UNITED STATES  
NUCLEAR REGULATORY COMMISSION  
WASHINGTON, D.C. 20555-0001

SUBJECT: QUAD CITIES NUCLEAR POWER STATION, UNITS 1 AND 2- STAFF  
ASSESSMENT OF RESPONSE TO 10 CFR 50.54(f) INFORMATION REQUEST  
- FLOOD-CAUSING MECHANISM REEVALUATION (CAC NOS. MF1108 AND  
MF1109)

STAFF ASSESSMENT BY THE OFFICE OF NUCLEAR REACTOR REGULATION  
RELATED TO FLOODING HAZARD REEVALUATION REPORT  
NEAR-TERM TASK FORCE RECOMMENDATION 2.1  
QUAD CITIES NUCLEAR POWER STATION, UNITS 1 AND 2  
DOCKET NOS. 50-254 AND 50-265

Figure 3.2-1. Probable Maximum Precipitation Distribution at Quad Cities Nuclear Power Station (1-h 1-mi<sup>2</sup>) (Exelon, 2015a)

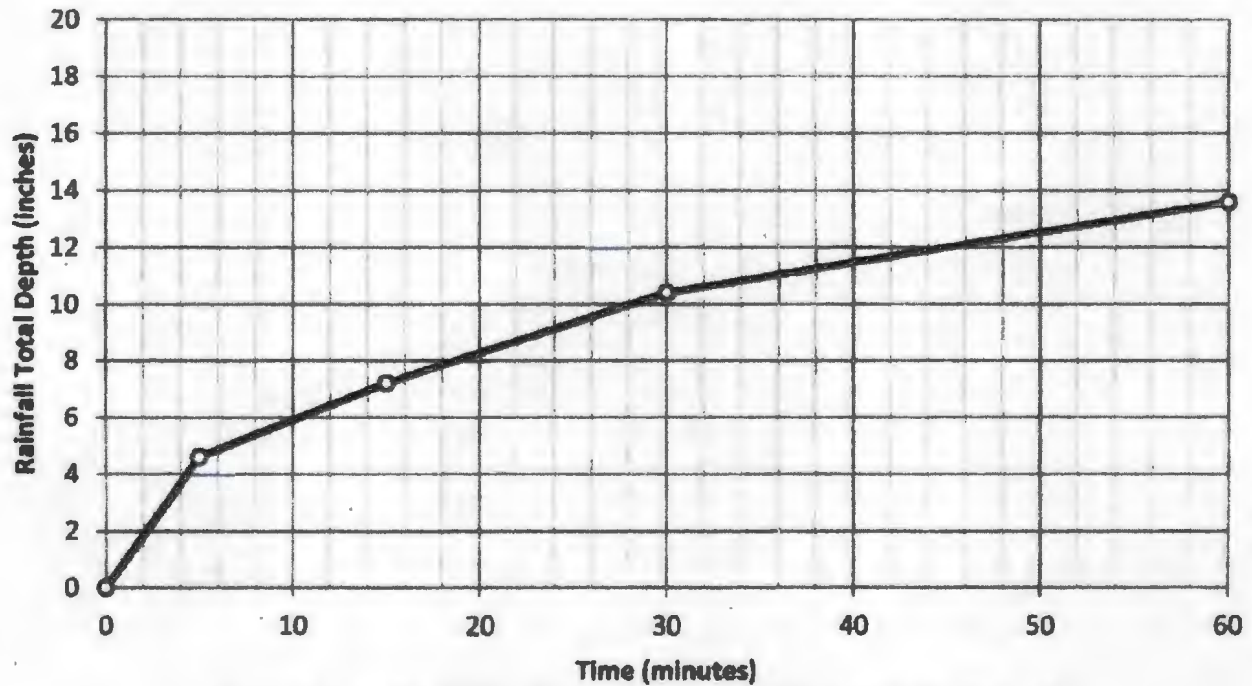
The NRC staff performed a separate sensitivity analysis on the temporal distribution of the rainfall (ORNL, 2015). The sub-hourly PMP depths for the 5-minute (min), 15-min, and 30-min time intervals were calculated by the licensee using ratios obtained from Figures 36, 37, and 38 of HMR 52 (Exelon, 2015a; NOAA, 1982). The rainfall hyetograph was arranged by the licensee using a front-loaded distribution, with the highest rainfall intensity occurring at the event onset (Exelon, 2015a). The licensee stated that the type of storm indicative of an LIP event would likely be a mesoscale convective system, which is associated with a zone of convergence and very intense initial precipitation that would maintain "a decrease in the precipitation after the initial burst as the rear trailing stratiform region with the cold pool moves over the area," thus fitting with a front loaded distribution (Exelon, 2014b). While this statement is true for some historical LIP-scale storms, alternative rainfall distributions have also frequently occurred. The

NRC staff's sensitivity analysis changed the rainfall distribution in the hydraulic model (FLO-2D) to a center weighted temporal distribution, as shown in Figure 3.2-1, and then computed the maximum water surface elevation at various locations around the site (ORNL, 2015). As expected, the results of this sensitivity study did increase the water depths around the site. However, the increases in water depths were small, with differences of 1.1 to 3.4 in. (2.7 to 8.6 cm) of the licensee's results (ORNL, 2015). Therefore, the NRC staff concluded that the licensee's temporal distribution of the ssPMP values is reasonable input to the hydraulic model and site drainage analysis discussed below.

Figure 4.2-1. Flood Event Durations for Failure of Dams and Onsite Water Control and Storage Structures at Quad Cities, Units 1 and 2 (Elevations in MSL) (Exelon, 2015b)

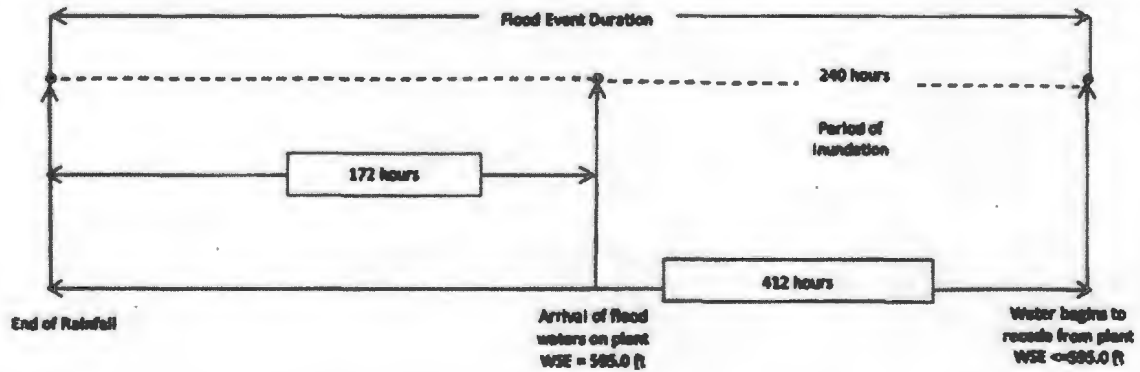
For the combined dam failure event, the licensee stated all FED parameters are based on the HEC-RAS hydraulic modeling (Exelon, 2014b). The licensee defined the warning time as the time from when the PMP rainfall ended to the when the flood waters exceeded plant grade (594.5 ft (181.20 m) MSL), which the licensee computed to be 172-h (Exelon, 2014b). The licensee defined the inundation time as the time from when flood waters exceed plant grade to when the flood waters receded below plant grade, which the licensee determined to be 240-h (Exelon, 2014b). Both of these definitions are visually represented in Figure 4.2-1. The NRC staff reviewed the HEC-RAS model, and agreed with these FED parameters, as defined by the licensee. The NRC staff noted that the warning time definition from the licensee is different than the NRC staff definition. However, the NRC staff noted that the licensee definition starts at the end of the PMP event, which is a quantifiable start time, rather than an estimated forecast of when a PMP event may start. Also, forecasts occur before or early in an event, which would result in a longer temporal difference than using the end of the event. Therefore, the NRC staff determined that the 172-h to be a more accurate and more conservative warning time. The licensee did not provide the recession time for the combined dam failure event. The licensee did not provide any FED parameters for LIP flooding.

The licensee is expected to develop FED parameters designated as "Not Provided" in Table 4.2-1 to conduct the MSA or additional assessments of plant response. The NRC staff will review these FED parameters as part of future additional assessments of plant response, if applicable to the assessment and hazard mechanism.
